Koonung Creek Reserve

Draft Concept Design Engagement

City of Boroondara

09.11.23

Figure 11114 Draft Concept Design of Koonung Creek Reserve

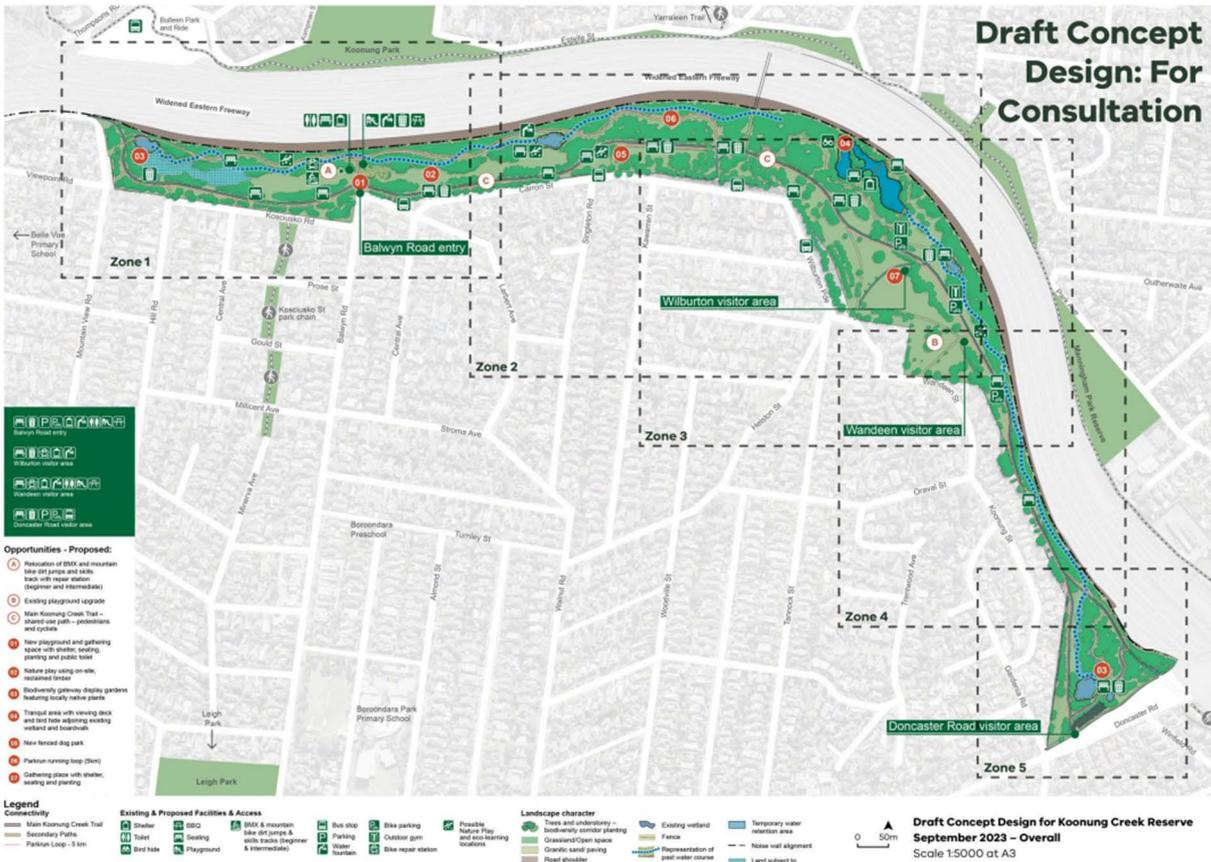
- Participants were generally concerned that 20% of the park will be taken by NELP.
- General agreement that mode separation makes it safer for cyclists and pedestrians. However participants noted that pedestrians will not walk closer to the road, have them be on the inside of the reserve.

- General acceptance of the inclusion of the BMX track but noting that it would compromise open space. There were suggestions to fence in the BMX track area.

- There were suggestions to fenced off the playgrounds to ensure safety of children.
- There was preference for an extra path along the top northern edge to replace the water retention feature.

- Participants noted that there is a reduction in utility in this design with no access behind the wetland. They suggested there should still be a path access behind this area (with a gravel path).

- Participants noted that the Tai Chi group use the gazebo every morning and suggested that it should be a sheltered space for Tai Chi users.
- Desire for the dog beach, exercise equipment and the Bee Hotel to be retained.

- Suggestion to include interpretive signage in the reserve.
- Regarding dog activities, there were suggestions to separate path for dog walkers in the northern part of the reserve; and a general comment that separating small and big dogs may not be worthwhile.
